PETITION FOR SPECIAL EXCEPTION 84-322-XA

PETITION FOR ZONING VARIANCE 84-322-XA

Re: Item No. 231 - Case No. 84-322-XA
Petitioner - Carey A. Piekarski
Special Exception & Variance Petitions

SITE PLAN AND PLAN FOR VARIANCE AND SPECIAL EXCEPTION SERVICE GARAGE

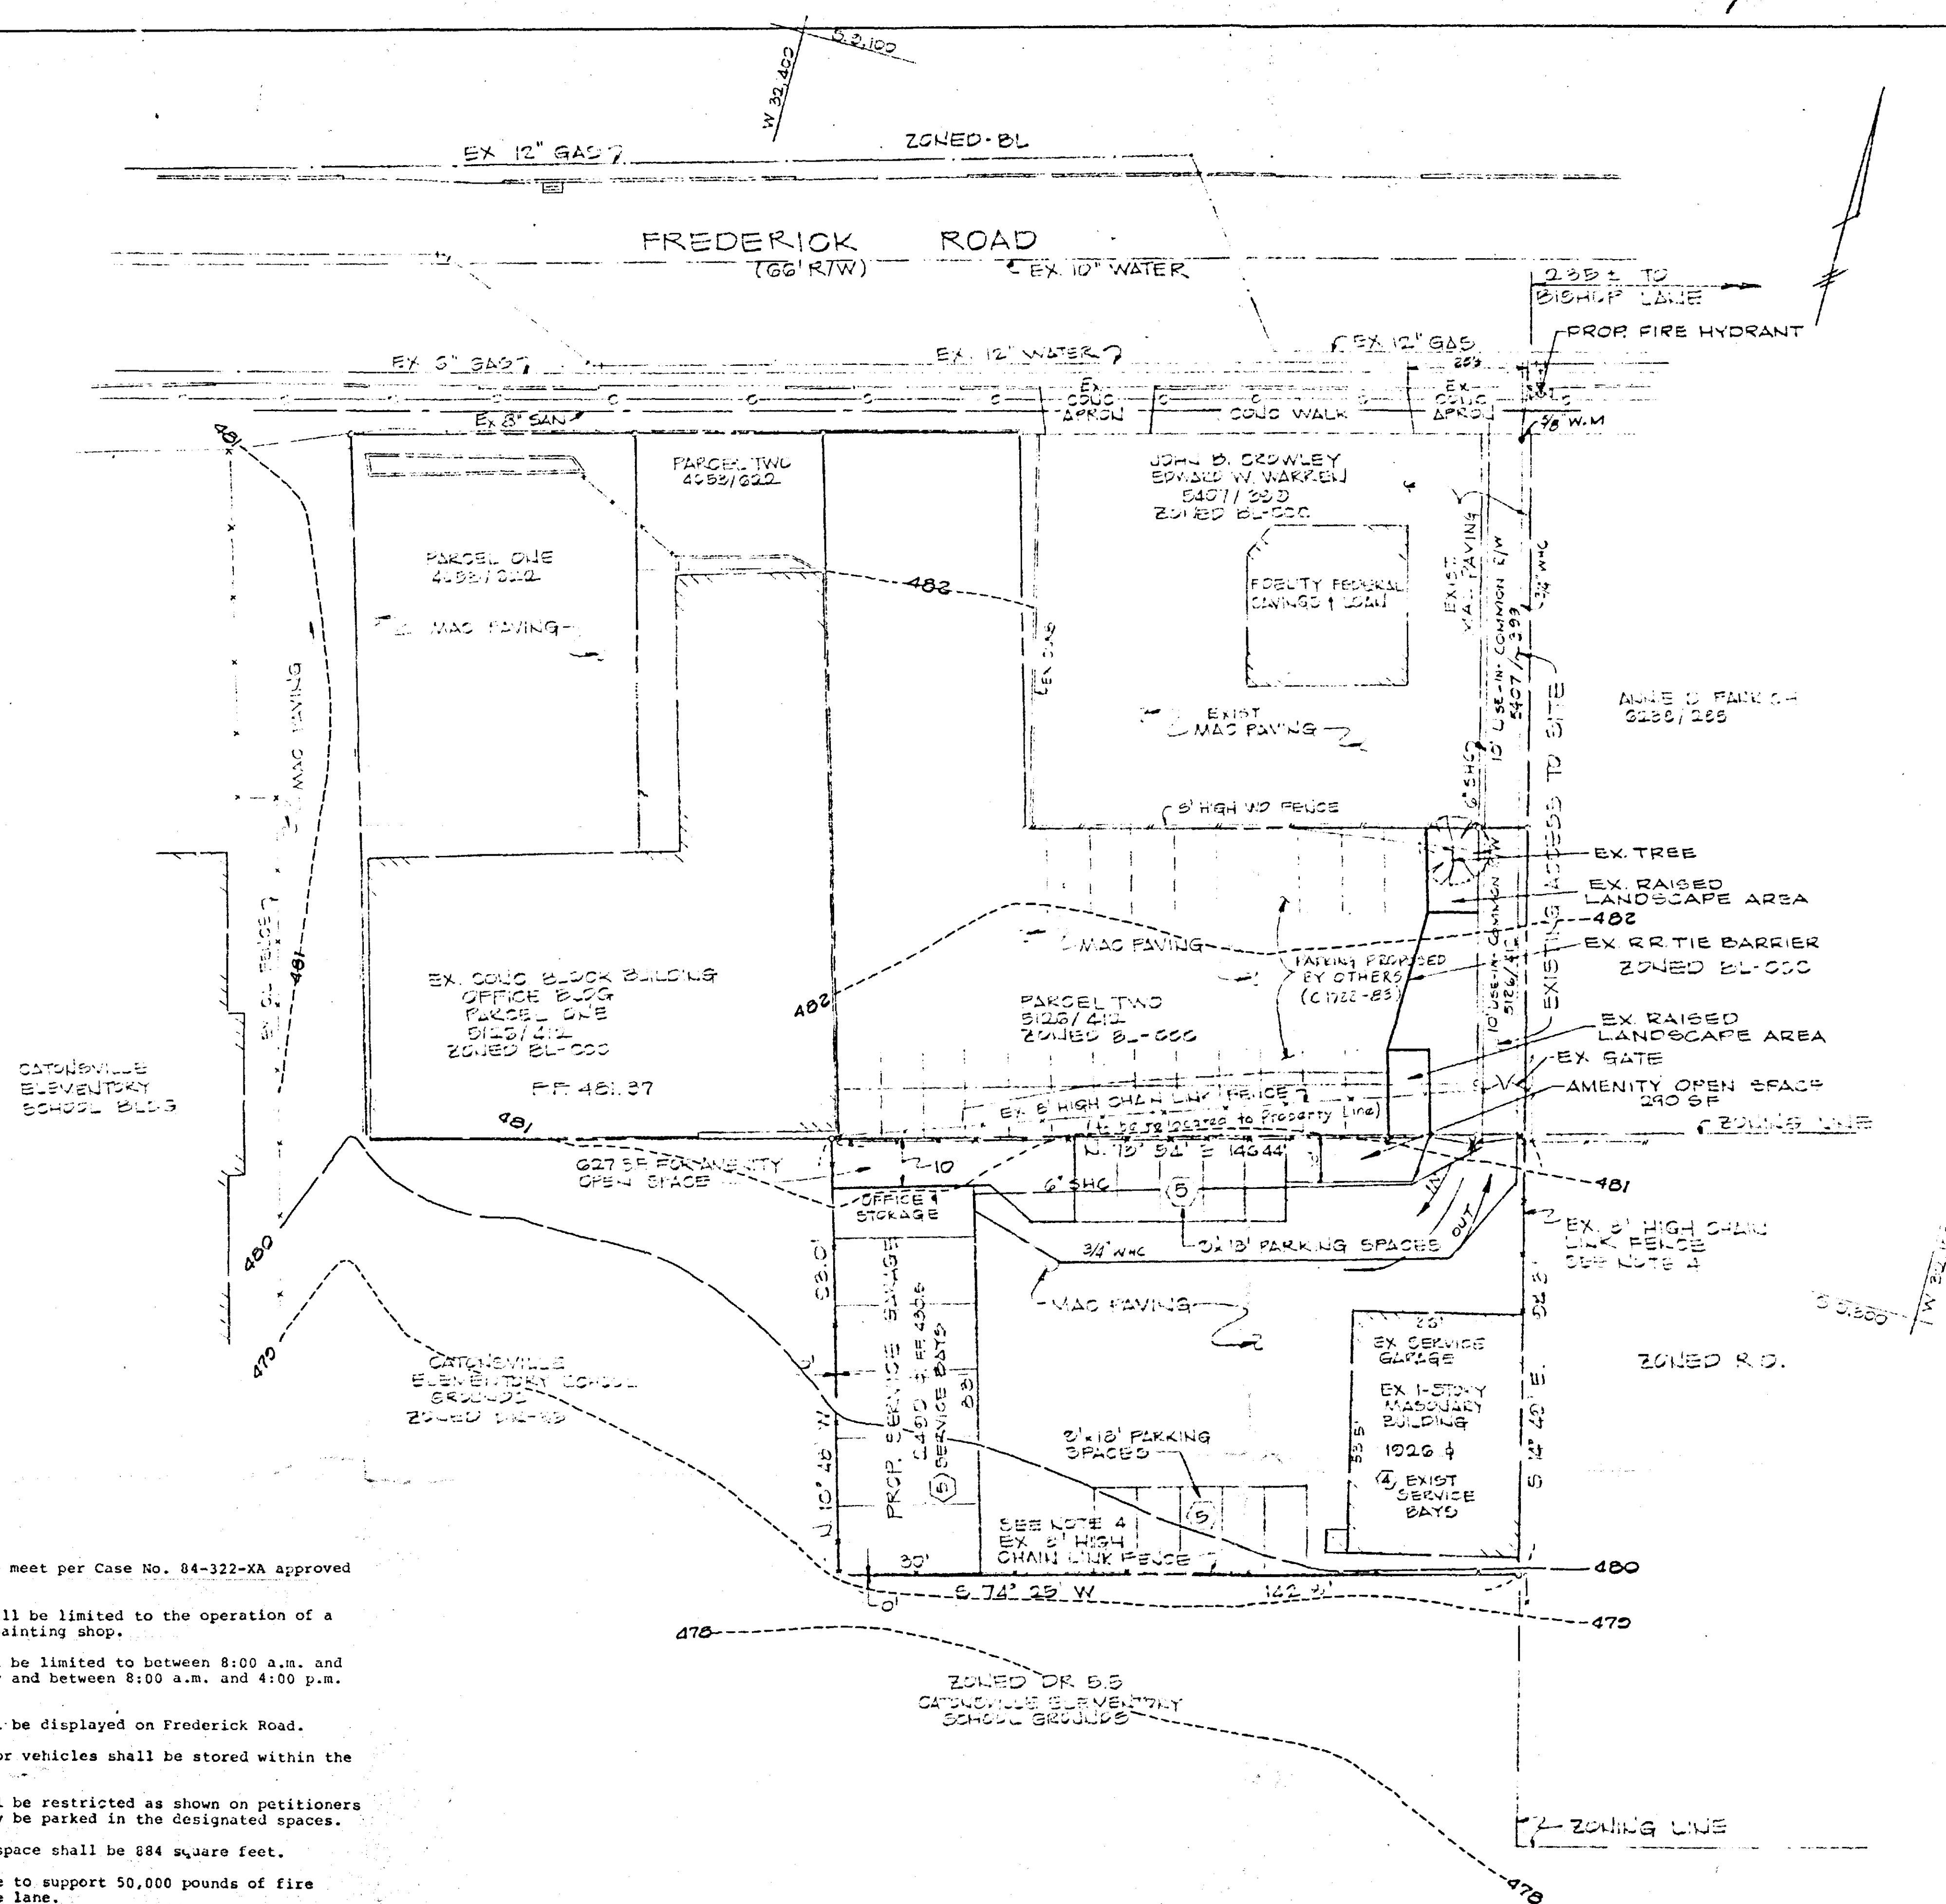
- A Revised Site Plan shall be submitted and approved by the Maryland Department of Transportation and the Office of Planning & Zoning, including landscaping required by the Current Planning and Development Division.

The Site Plan for the subject Building Permit Application has been revised as follows:

1. The amount of Amenity Open Space shown on the Plan has been clarified.
2. A proposed fire hydrant is shown along Frederick Road adjacent to the point at which the subject property gains access to that road.

LANDSCAPE PLAN
 SERVICE GARAGE
 KNOWN AS 609 FREDERICK ROAD
 FIRST DISTRICT BALTIMORE MD
 SCALE 1" = 20' OCTOBER 1984
 DEED REF: 4852/12

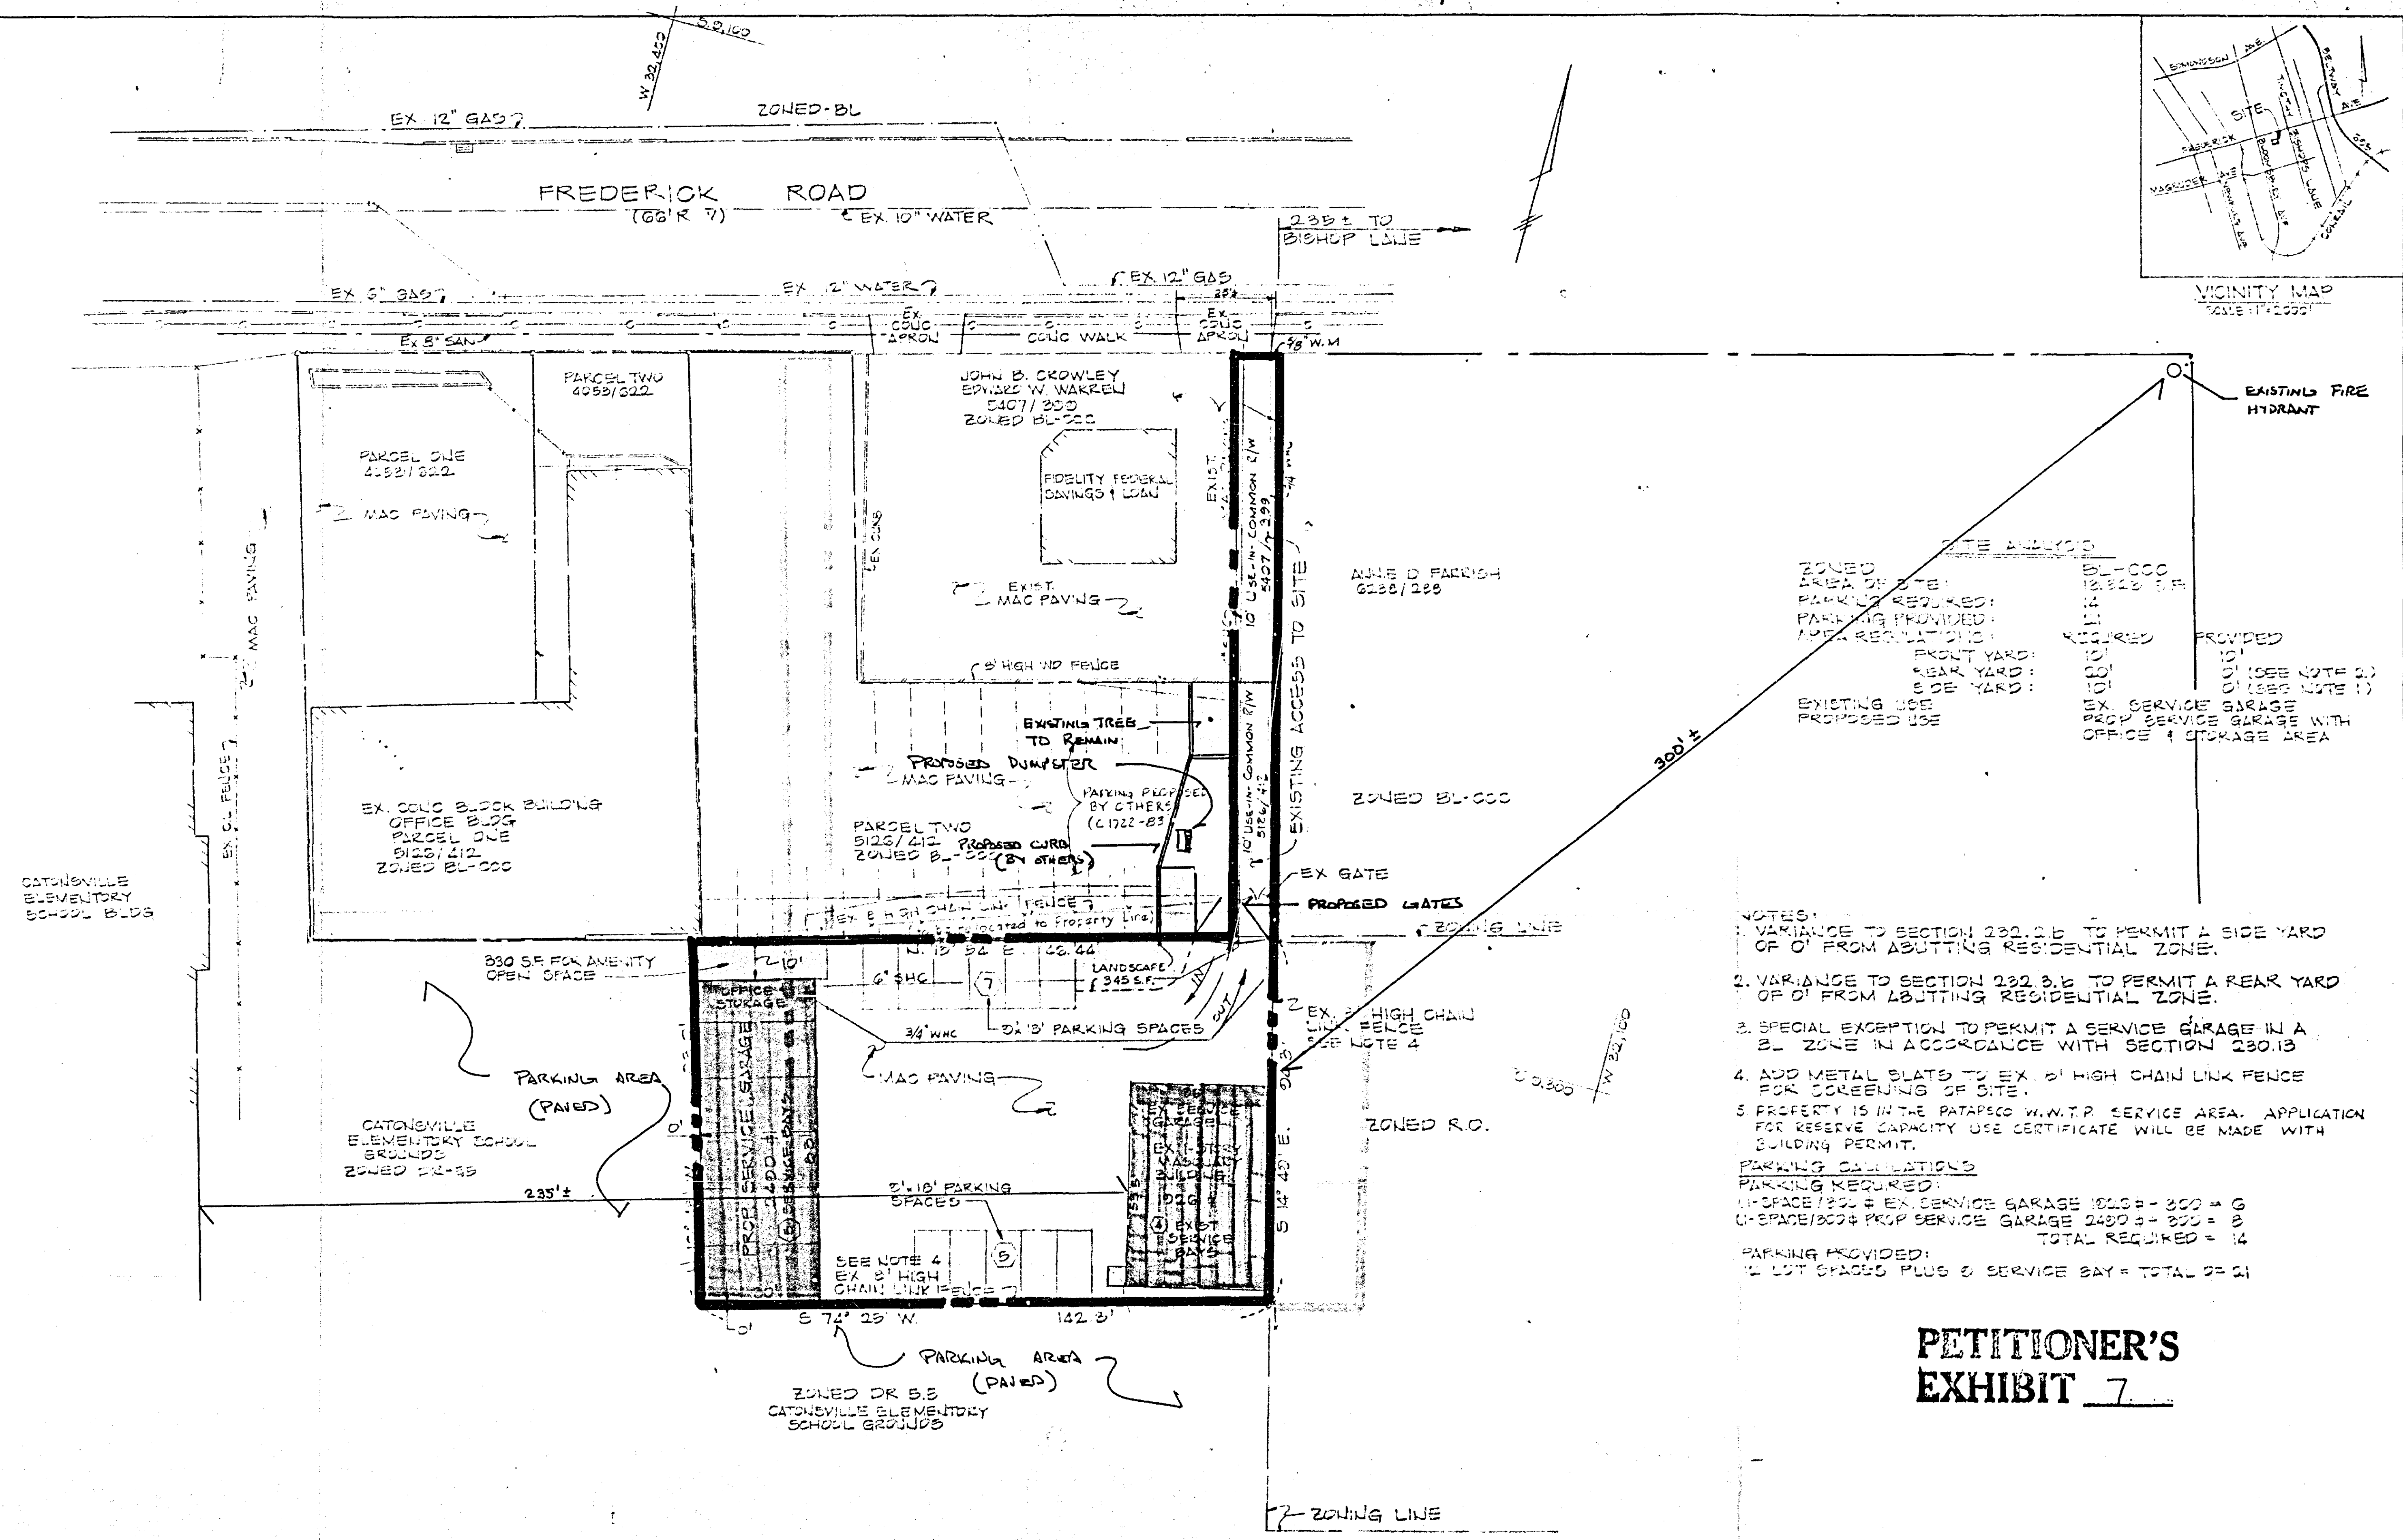
- A Revised Site Plan shall be submitted and approved by the Maryland Department of Transportation and the Office of Planning & Zoning, including landscaping required by the Current Planning and Development Division.

LANDSCAPE PLAN
SERVICE GARAGE
 KNOWN AS 609 FREDERICK ROAD
 FIRST DISTRICT BALTIMORE CO. MD.
 SCALE: 1" = 20'
 SEPT, 1984
 DEED REF: #852/12

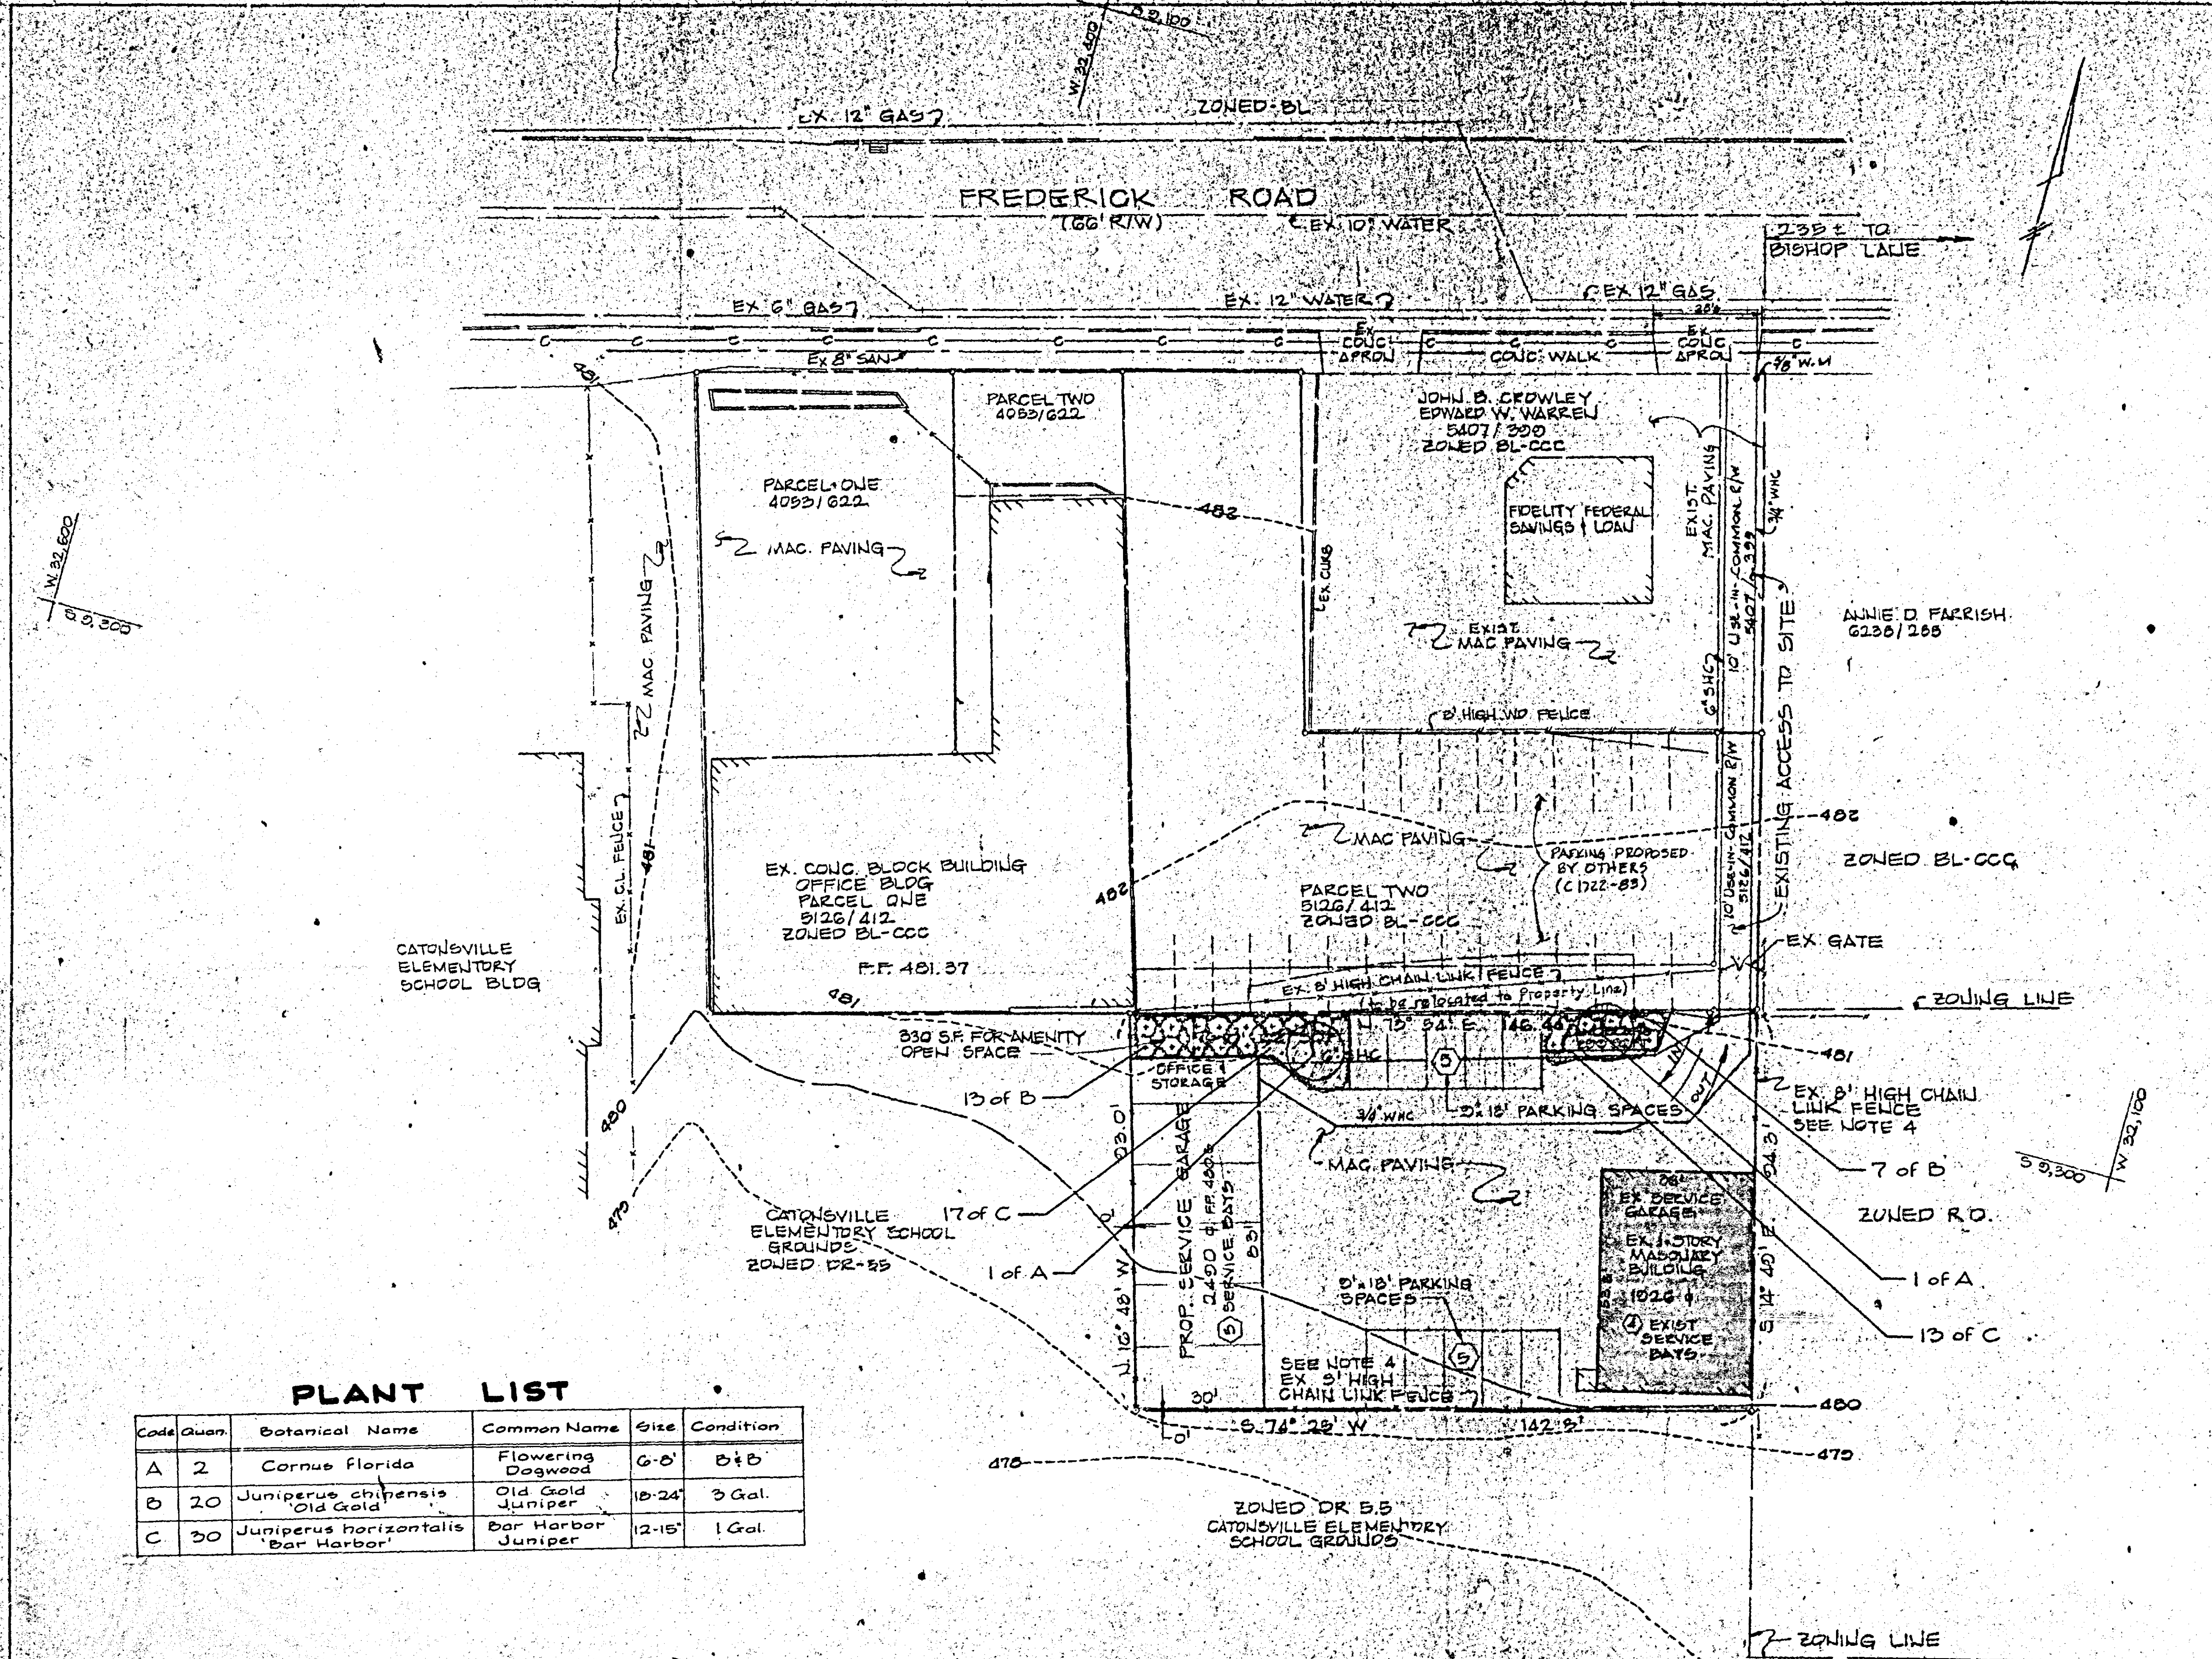
If granted, it is requested that details of landscaping be required.
